## PCI-SIG ENGINEERING CHANGE NOTICE

<b>TITLE:</b>	Generic Capability Structure for SATA Host Bus Adapters
<b>DATE:</b>	October 17, 2004
<b>AFFECTED DOCUMENT:</b>	PCI 3.0
<b>SPONSOR:</b>	Robert Strong, Intel

## SATACR - Serial ATA Capability Register

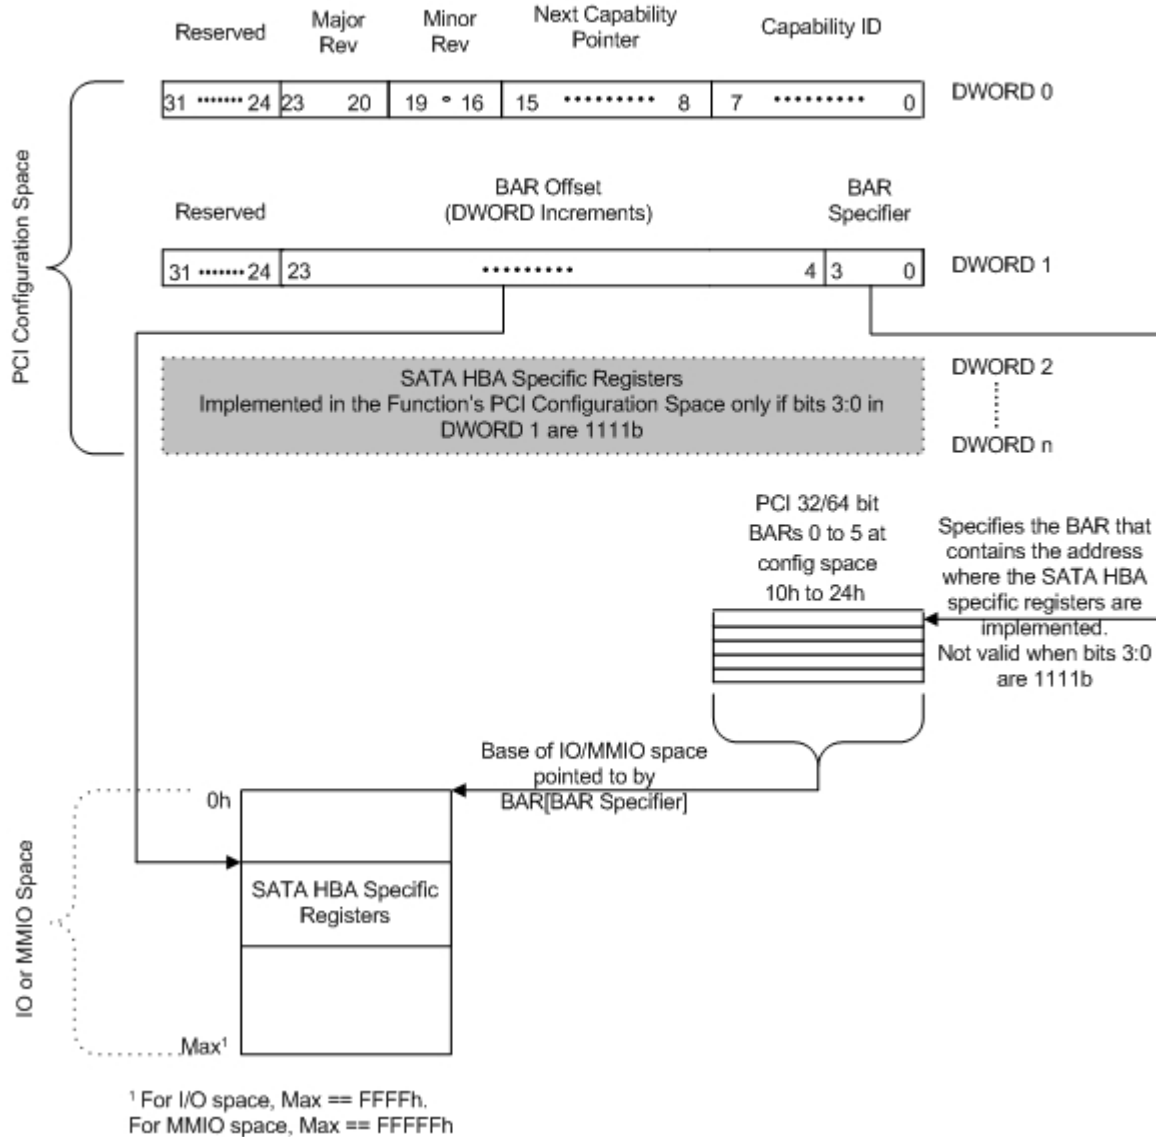
The functional changes proposed involve the definition of a new Capabilities List ID (and associated Capability register set). This new Capabilities ID will identify to system firmware (BIOS/OROM), a Serial ATA (SATA) host bus adapter's (HBA) support of optional features that may be defined in the particular SATA HBA specification (i.e. Advanced Host Controller Interface - AHCI). ***It is important to note that this capability register is intended for use by pre-boot software that may not have the ability to access SATA HBA specific MMIO registers that reside above 1MB. OS specific device drivers do not have this limitation and are expected to determine optional SATA HBA features through an examination of the HBA's specific capability register, which may be found in IO or MMIO space – this is SATA HBA specification dependent.***

*The capabilities provided by the SATA HBA are HBA specification specific; it is the responsibility of the system firmware to comprehend the exact implementation. The following outlines the format of the new Capability register:*

**Bits [7:0] – PCI SIG assigned Capability ID.** This SATA HBA feature has been assigned a Capability ID of 12h.

**Bits [15:8] – Pointer to Next Capability.** Specifies the offset into PCI configuration space where the next Capability pointer resides.

**Bits [19:16] – Minor Revision.** Specifies the minor revision level to which the capability register is built. This may differ across SATA HBA implementations and is SATA HBA specification specific.

**Bits [23:20] – Major Revision.** Specifies the major revision level to which the capability register is built. This may differ across SATA HBA implementations and is SATA HBA specification specific.

**Bits [31-24] – Reserved.** Must return zero when read.

**Bits [3:0] – BAR Specifier.** Specifies which IO/MMIO space BAR in the function's PCI configuration space contains the SATA HBA specific registers. These bits represent an absolute offset (DWORD increments) into the device's PCI configuration space. These bits are read-only and may be assigned one of the following values:

**Bits [23:4] – BAR Offset.** Specifies the offset (DWORD increments) into the IO/MMIO space BAR where the SATA HBA specific registers are located. These bits are read-only and may be assigned (by hardware) the following range of values:

**SATA HBA Registers.** Specifies the SATA HBA specific registers. Only valid if bits 3:0 of DWORD 1 are 1111b. *Implementing the SATA HBA specific registers in PCI configuration space is useful for those HBA implementations that do not wish to provide IO decoders or do not want to provide a MMIO decoder for <1MB accesses.*
